ROLLING HILLS BOOSTER PUMP STATION SMALL SUBDIVISION DRAINAGE REPORT

(THE HILLS AT LORSON RANCH FILING NO. 1)

Add PCD File # PPR-21-075

DECEMBER 2021

From Lorson Range Filing #1 FDR

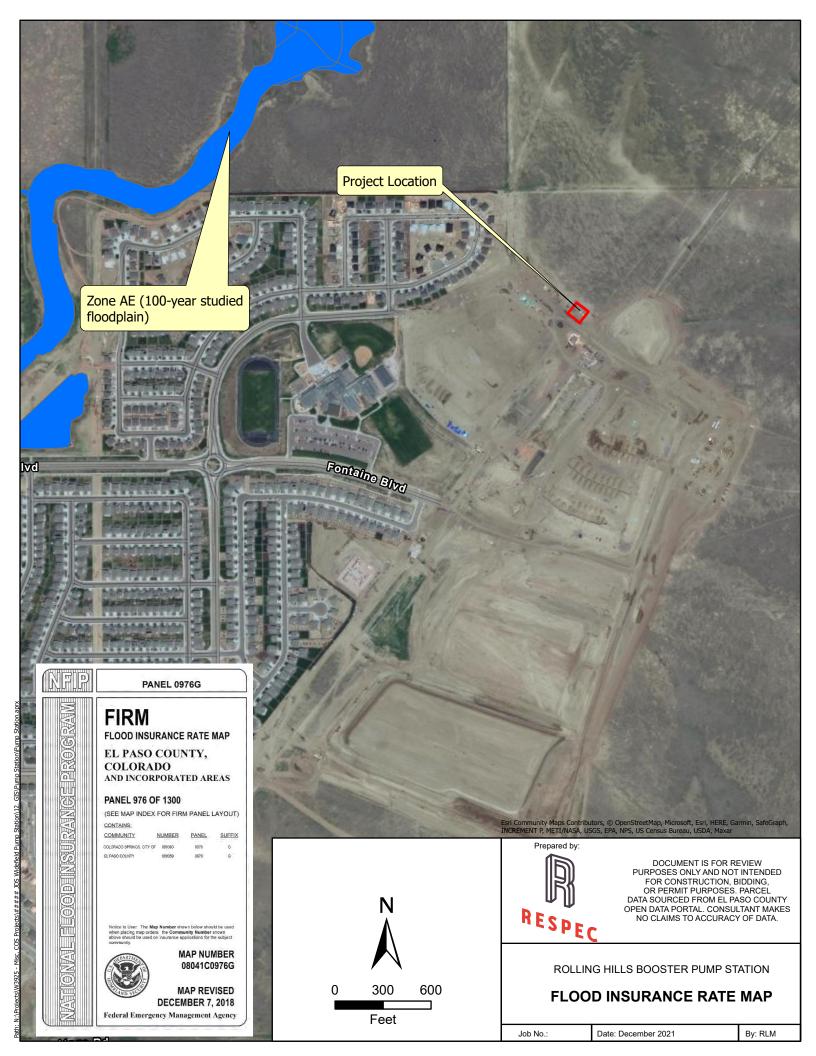
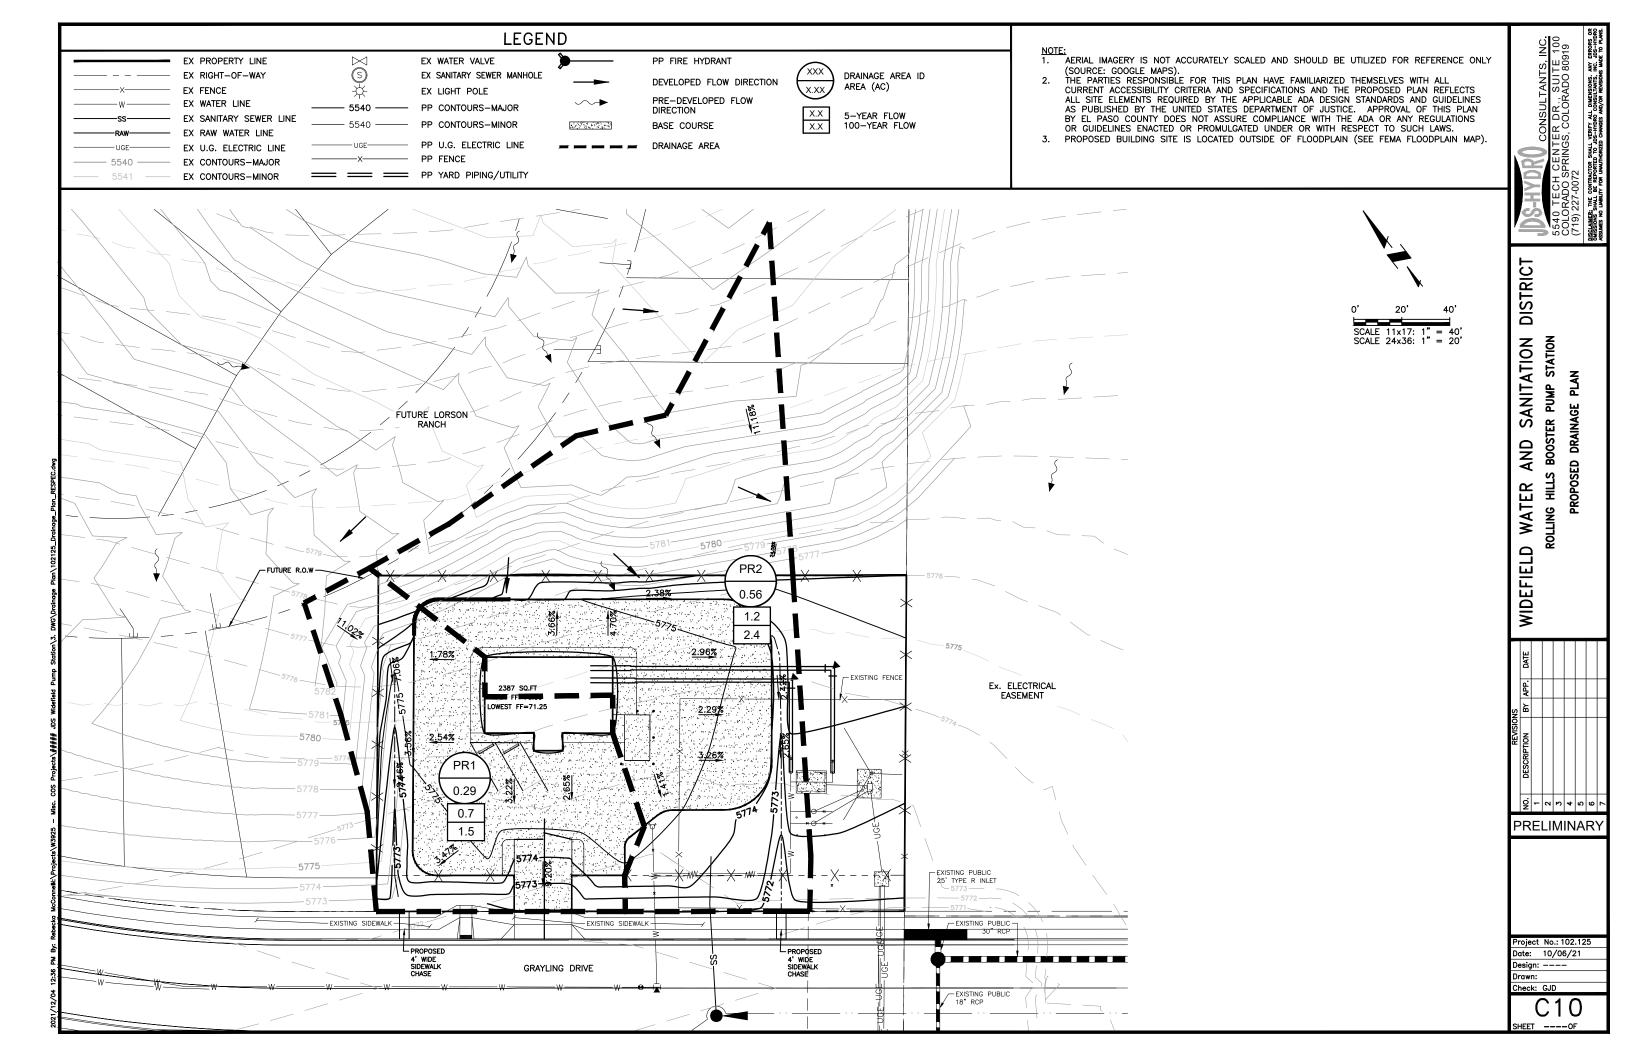
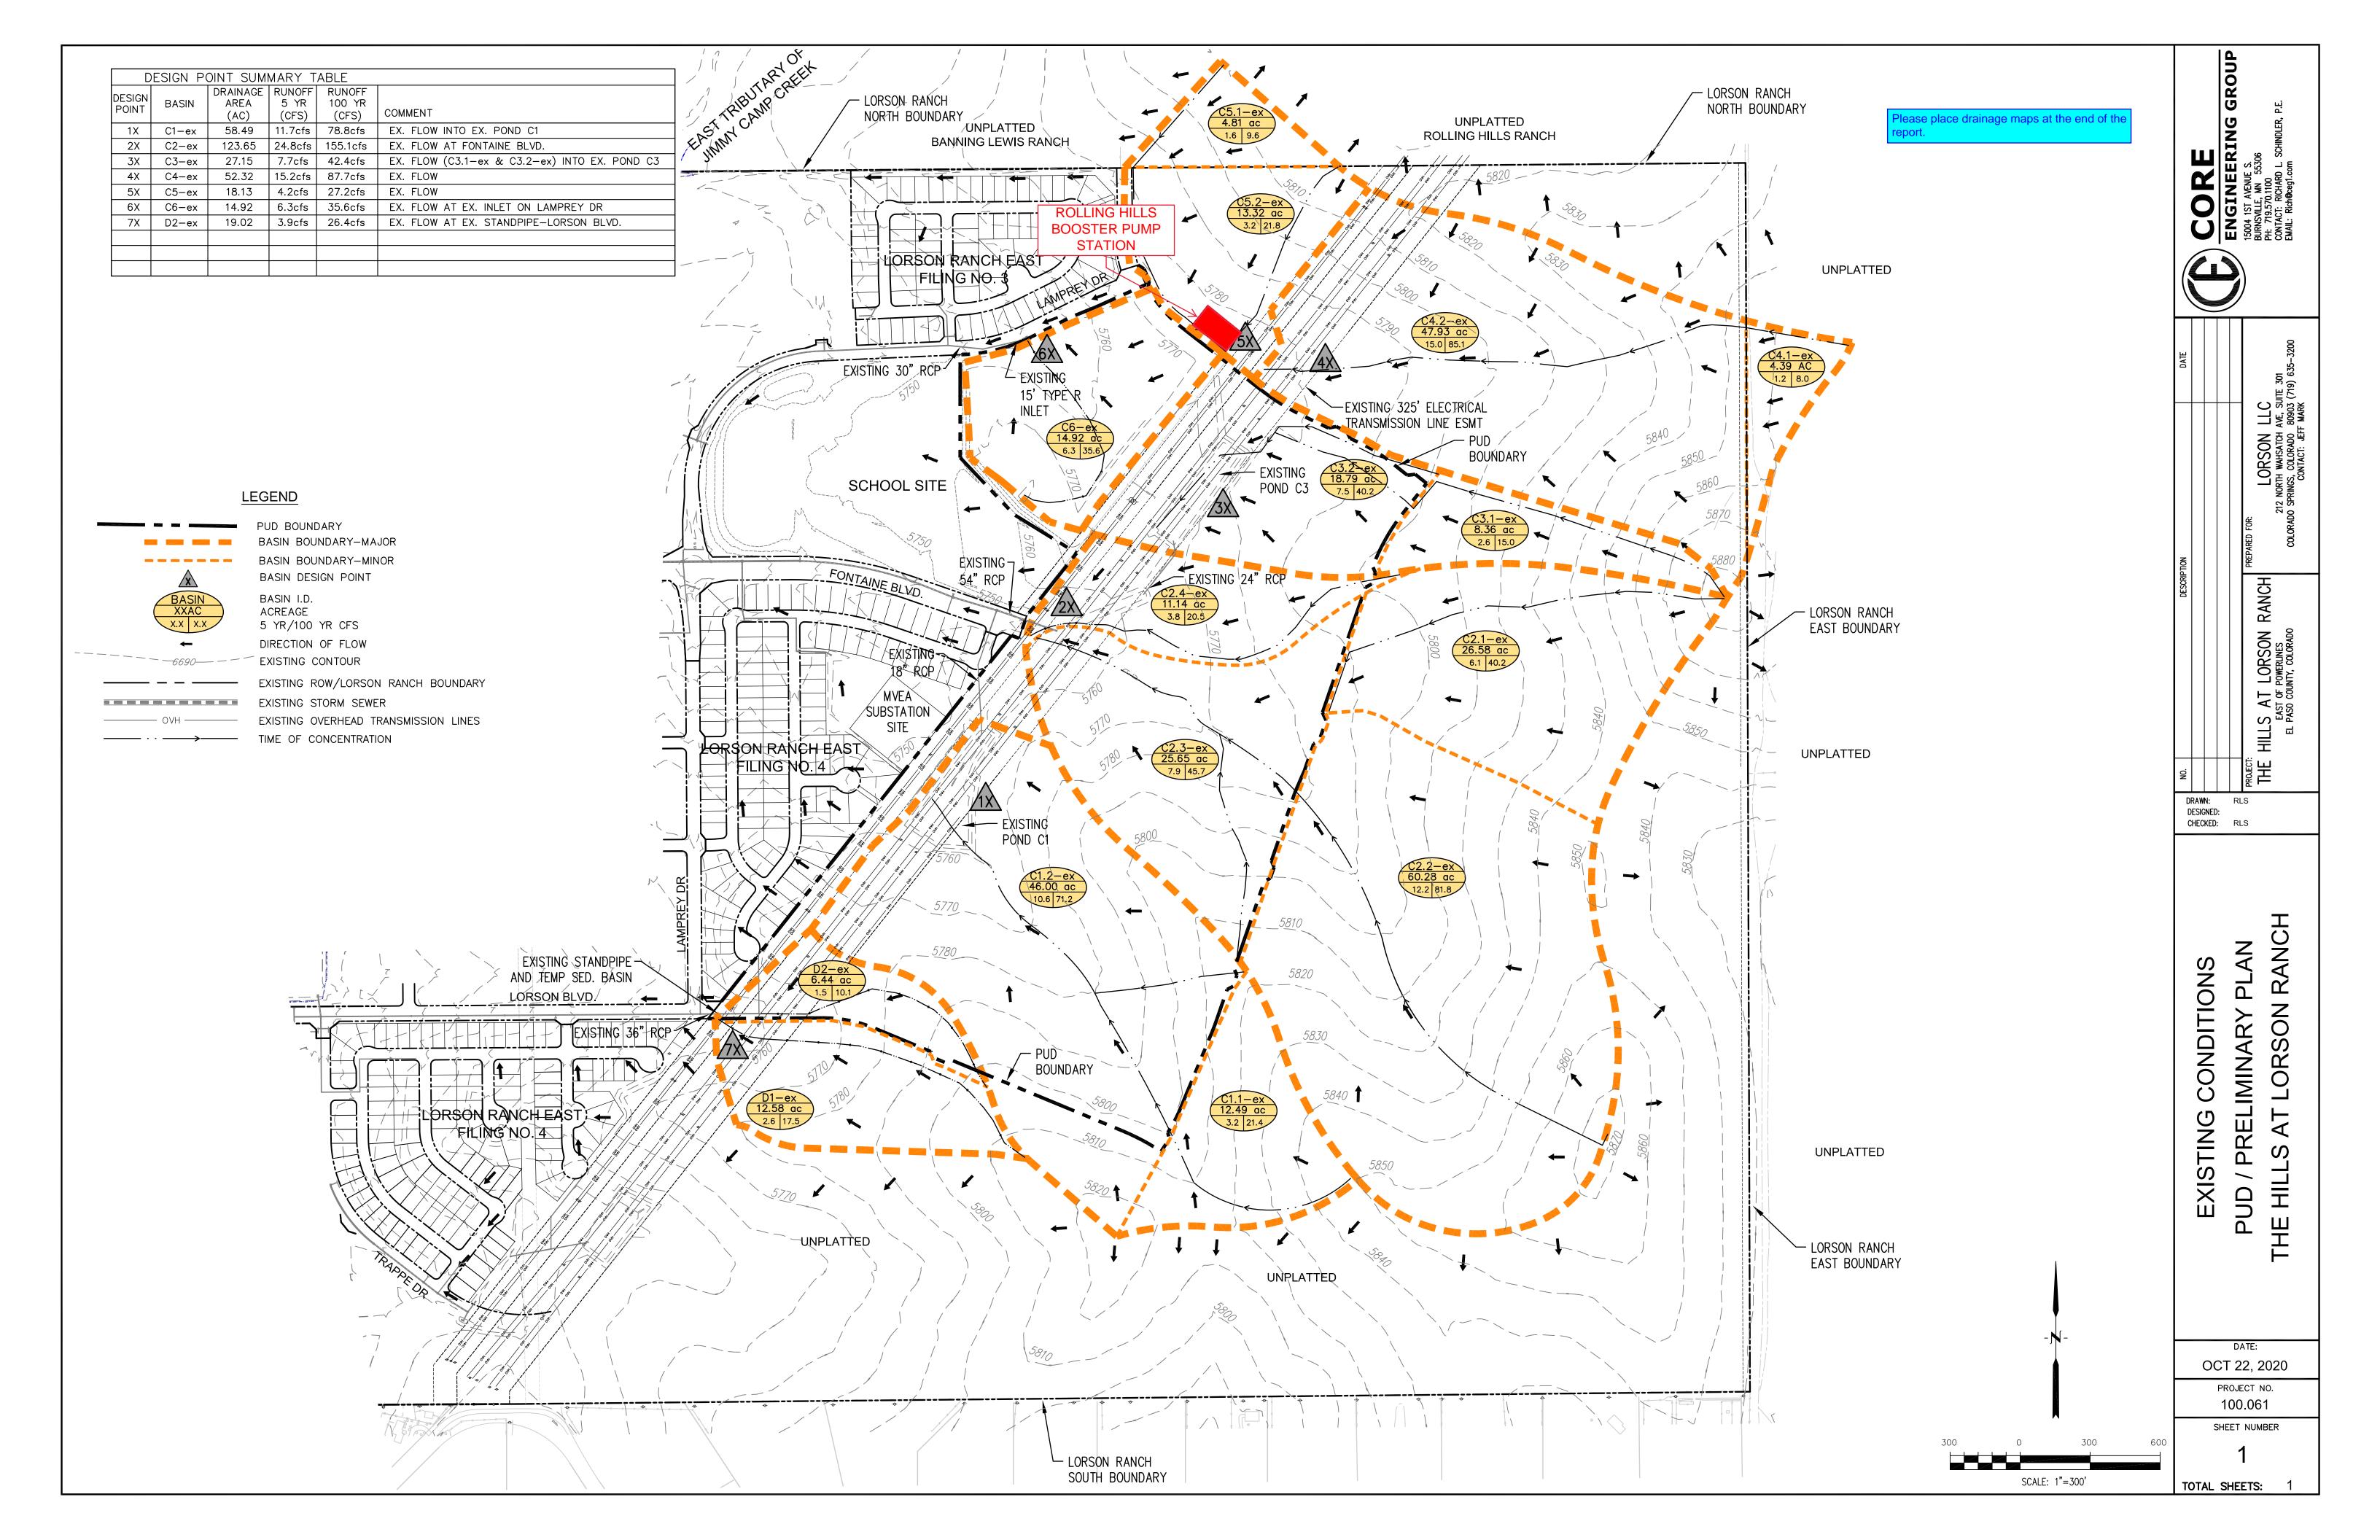
Drainage fee will be required when Skyline at Lorson Range Filing #1 is platted to include this area and tract. Please correct statement. This statement conflict with the FDR and Letter of Intent which states that Drainage Basin Fees will be paid.
